TECHNICAL BULLETIN INDEX
Sorted by Bulletin Number
04/03/86

BULLETIN NO.: III:1

PRODUCT: 26-1061/2/3/4/5/6 Model III

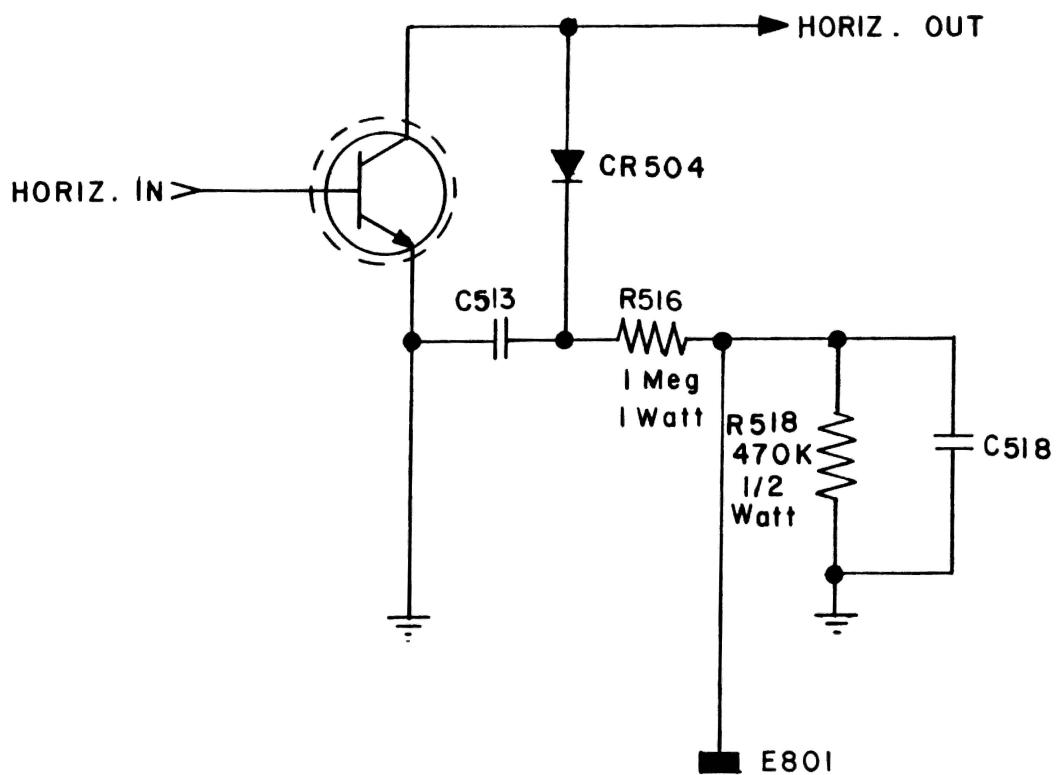
This problem has been found to be caused by a defective voltage divider network, R516 (1 Megohm, 1 watt) and R518 (470K ohm, 1/2 watt). The 1 Megohm resistor usually decreases in value, while the 470K ohm resistor generally increases in value.

Another possibility is a defective damper diode, CR504 (National Parts number ADX-1070). Note that it is possible for this diode to fail only during actual usage, so it may test good with an ohmeter, but still fail under normal use.

Measure the voltage at point E801. It should be between 150 VDC and 200 VDC. If it is not, measure and replace if necessary either R516 or R518, or both.

If it is necessary to replace the damper diode, you MUST use a FAST RECOVERY diode.

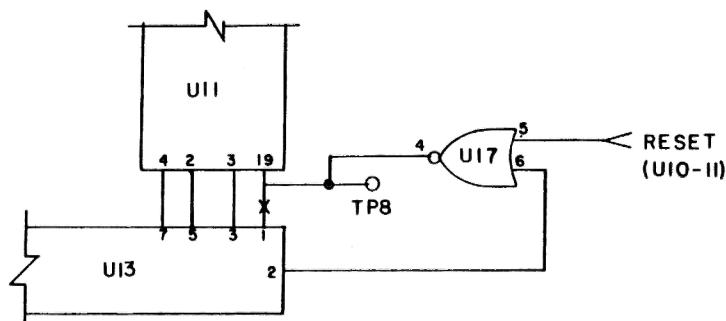
DISCUSSION:**THIS MODIFICATION IS MANDATORY TO ALL FDC BOARDS, REVISION A THROUGH REVISION E!!**

This modification compensates for an intermittent problem found in the WD1691 IC.

- 1) Cut trace between pin 1 of U13 (WD2143) and TP8.
- 2) Connect pin 2 of U13 (WD2143) to pin 6 of U17 (72LS02).
- 3) Connect pin 11 of U10 (74LS260) to pin 5 of U17 (74LS02).
- 4) Connect pin 4 of U17 (74LS02) to pin 19 of U11 (WD16791).
- 5) After performing the above modification, re-align the FDC board as per Technical Bulletin III:3.

Re-alignment after modification is MANDATORY.**Radio Shack®**

FIGURE 1

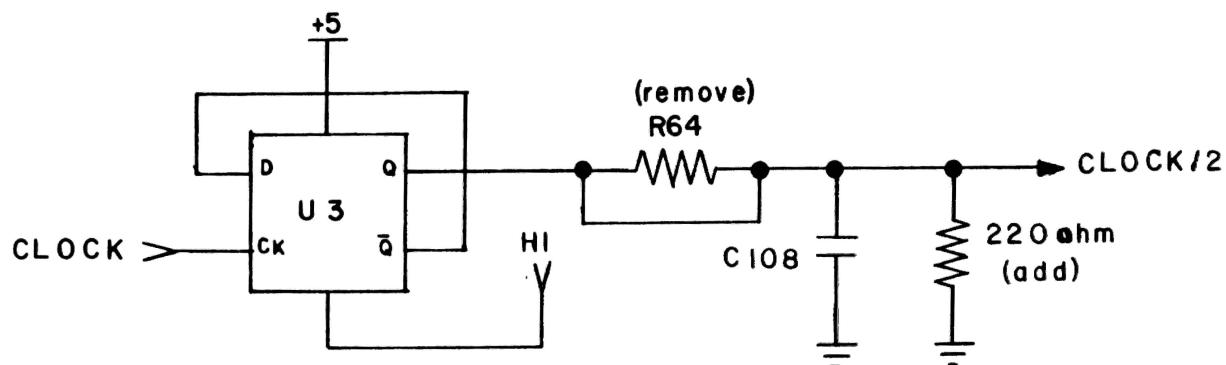
CHANGE #1 IS TO BE DONE ON THE REVISION 'F' CIRCUIT BOARD:

- 1) Remove R64. Replace it with an INSULATED jumper.
- 2) Remove C108. Replace it with a 220 pf disk capacitor.
- 3) Add a 220 ohm 1/4 watt 5% resistor from the 'R64' hole adjacent to U4 pins 5 and 6, to the grounded side of C108.

FIGURE 2

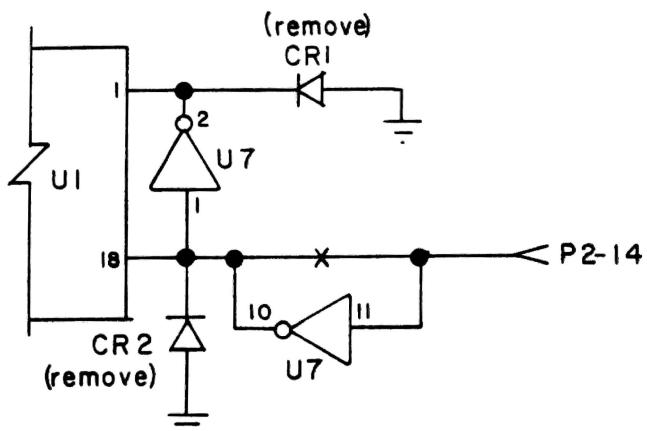
CHANGE #2 IS TO BE DONE TO THE RS232 BOARD:

- 1) Cut the trace between P2 pin 14 and U1 pin 18. Cut near C3.
- 2) Change U7 from a 74LS04 to a 7404 (National Parts number AMX-3655).
- 3) On the SOLDER side of the RS232 board connect a wirewrap jumper from U7 pin 11 to the feedthru connected to P2 pin 14.
- 4) On the SOLDER side of the RS232 board connect a jumper between U7 pin 10 to U7 pin 1.
- 5) Remove CR1 and CR2.

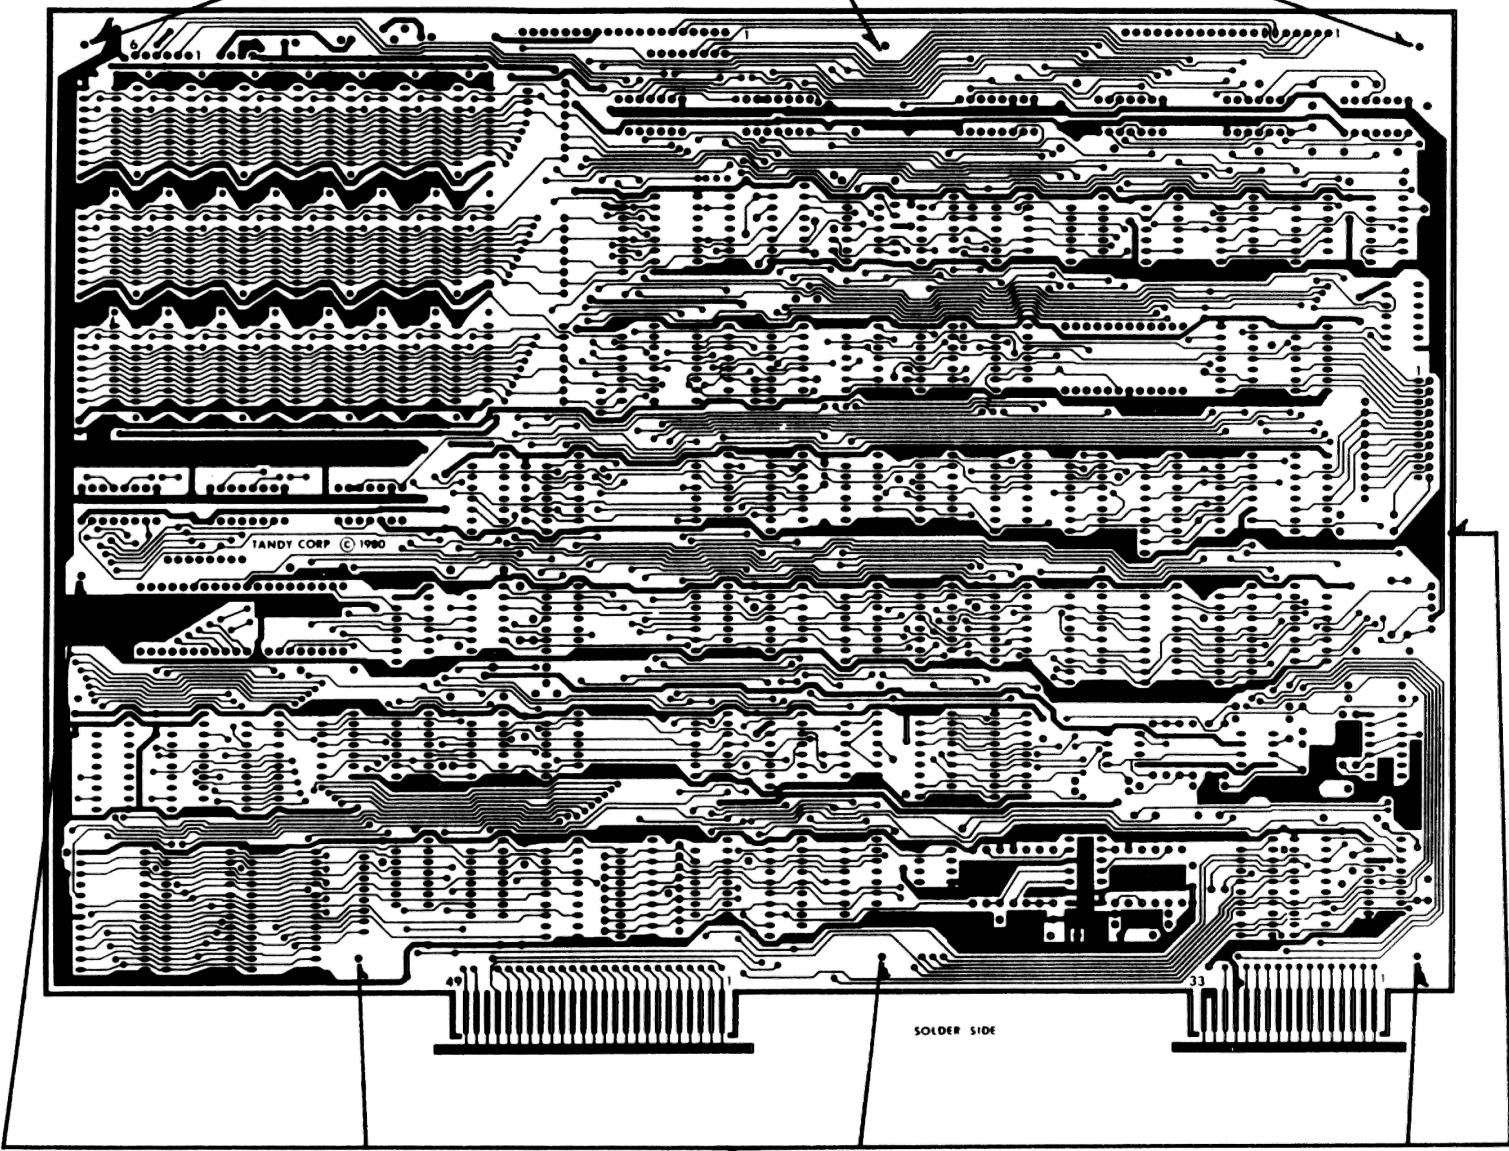
There are mylar washers attached to the PCB to prevent accidental shorts between the PCB and the chassis. Their location is detailed in the attached drawing. The National Parts number of these washers is AHC-0787.

Check these washers to see if they are damaged or missing. Replace them if necessary.

Note that in some cases it may be necessary to use two washers to prevent shorts.

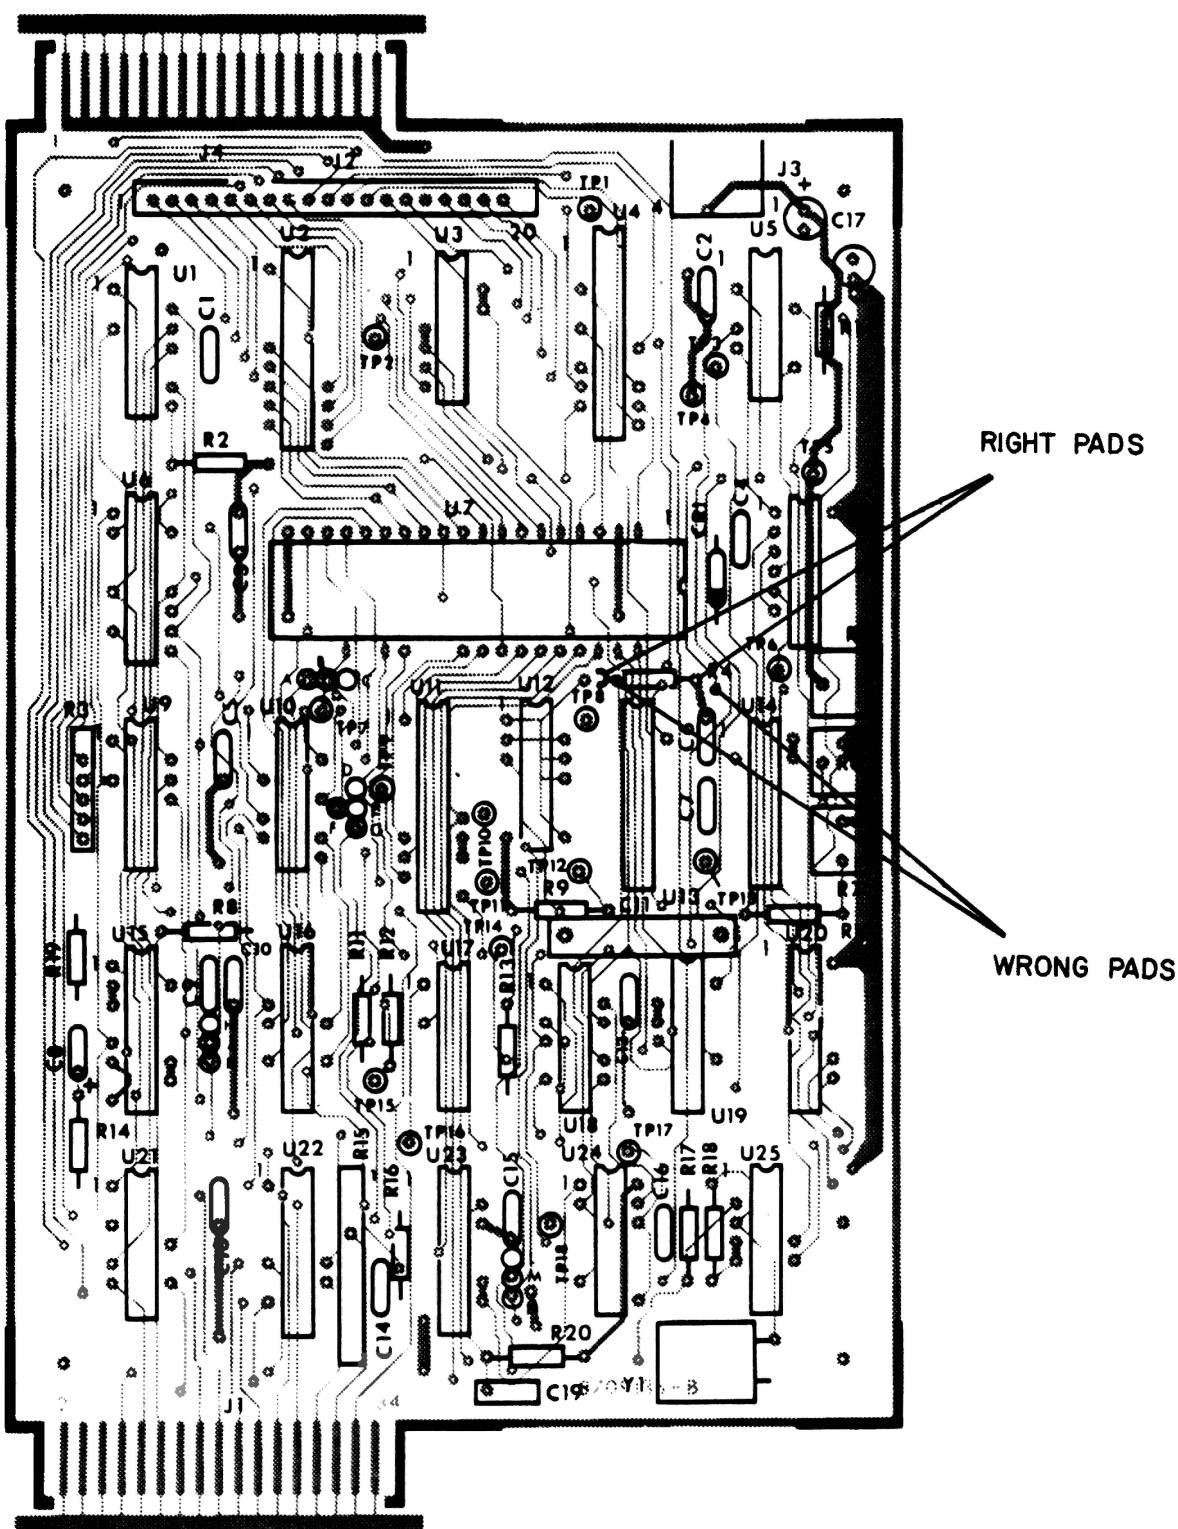
Some Model III FDC boards have been found with R4 installed on the wrong pads (see Figure 1). The correct pads have a white line between them.

ALL FDC boards should be checked to see that R4 is on the correct pads. If R4 is NOT installed correctly, simply remove it and re-install it on the correct pads.

NOTE: Cut pin 1 of U103 at the chip body.

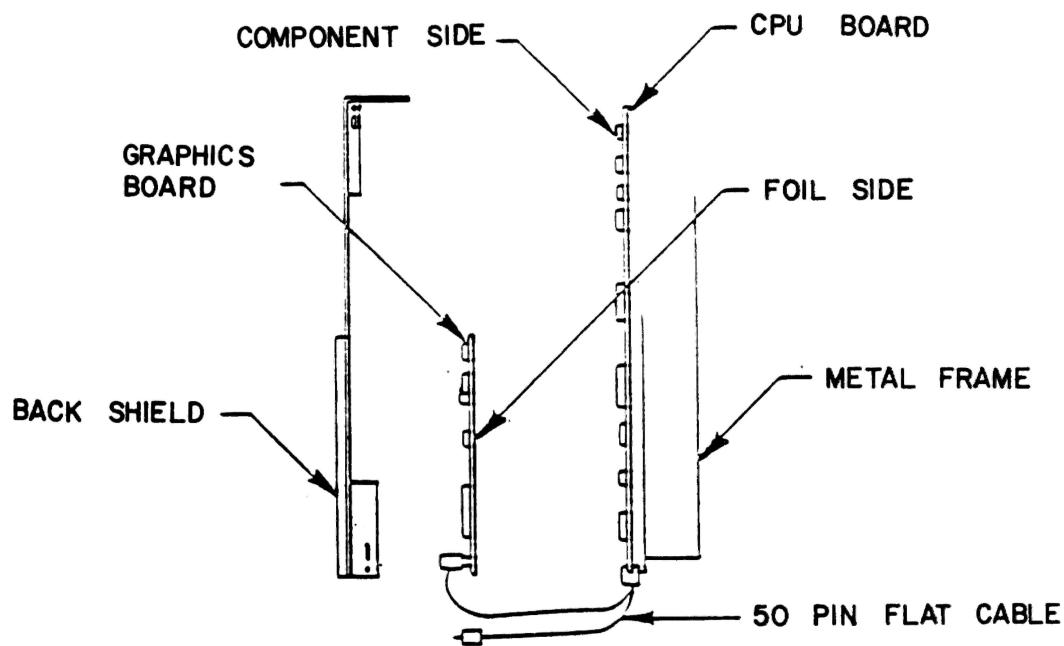
- A) Cut pin 1 of U103 away from the PCB. DO NOT cut the pin loose from the IC. Cut the pin right at the PCB. Refer to the attached drawing for clarification. Bend the pin up so that it can be soldered to later.
- B) Using a short piece of wire wrap wire, jumper U103 pin 1 (the pin just cut) to U87 pin 7 (ground).

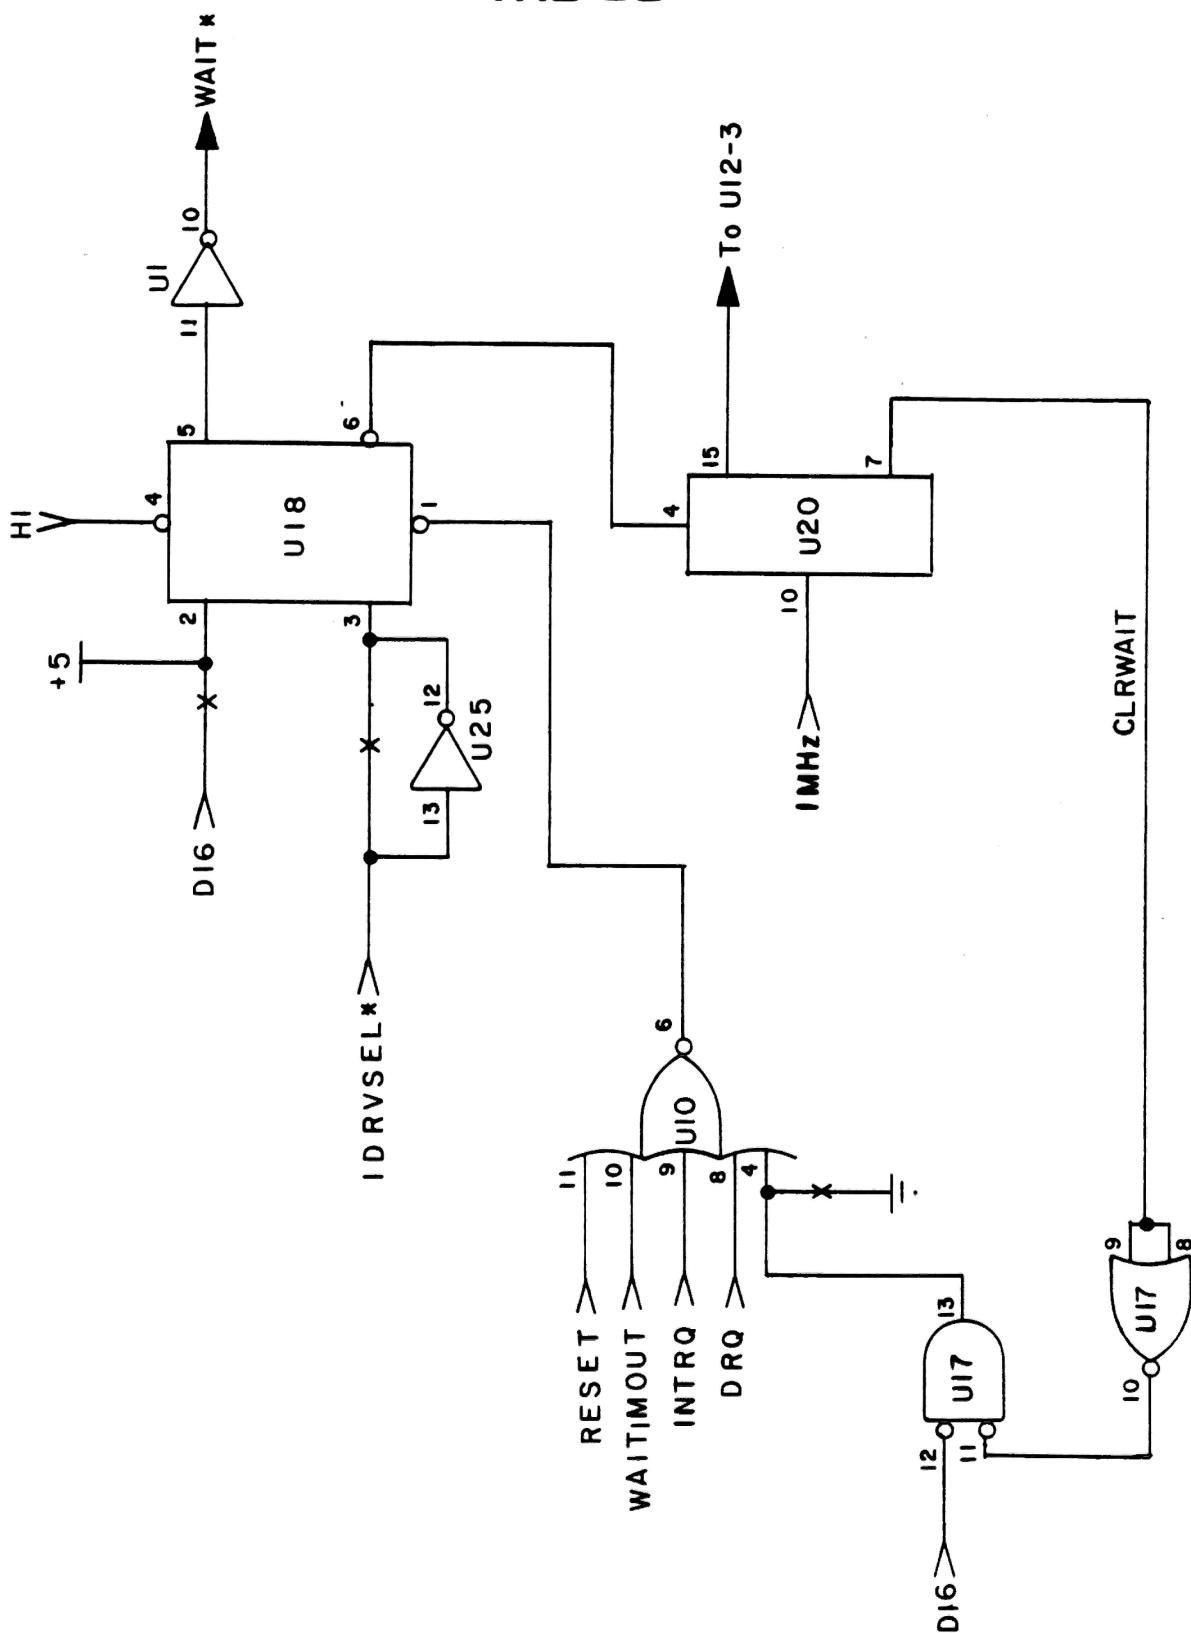
CUT THE PINS ON THE FOLLOWING ICs

- 1) U1Ø pin 4. Use the small dykes and cut the pin loose from the PCB. DO NOT cut the pin loose from the IC. Bend the pin upwards so you can solder to it later.
- 2) U18 pin 3. Use the small dykes and cut the pin loose from the PCB. DO NOT cut the pin loose from the IC. Bend the pin upwards so you can solder to it later.

USING WIRE WRAP WIRE, INSTALL THE FOLLOWING JUMPERS ON THE COMPONENT SIDE OF THE PCB. SOLDER DIRECTLY TO THE IC PINS.

- 1) U17 pin 13 to U1Ø pin 4 (the lifted pin).
- 2) U17 pin 12 to U19 pin 13.
- 3) U17 pin 1Ø to U17 pin 11.
- 4) U17 pin 9 to U17 pin 8 to U2Ø pin 7. Note that U17 pins 8 and 9 close together and can be connected by one end of the jumper to U2Ø pin 7.
- 5) U18 pin 2 to U18 pin 14.
- 6) U18 pin 3 (the lifted pin) to U25 pin 12.
- 7) U18 pin 11 to U25 pin 13.
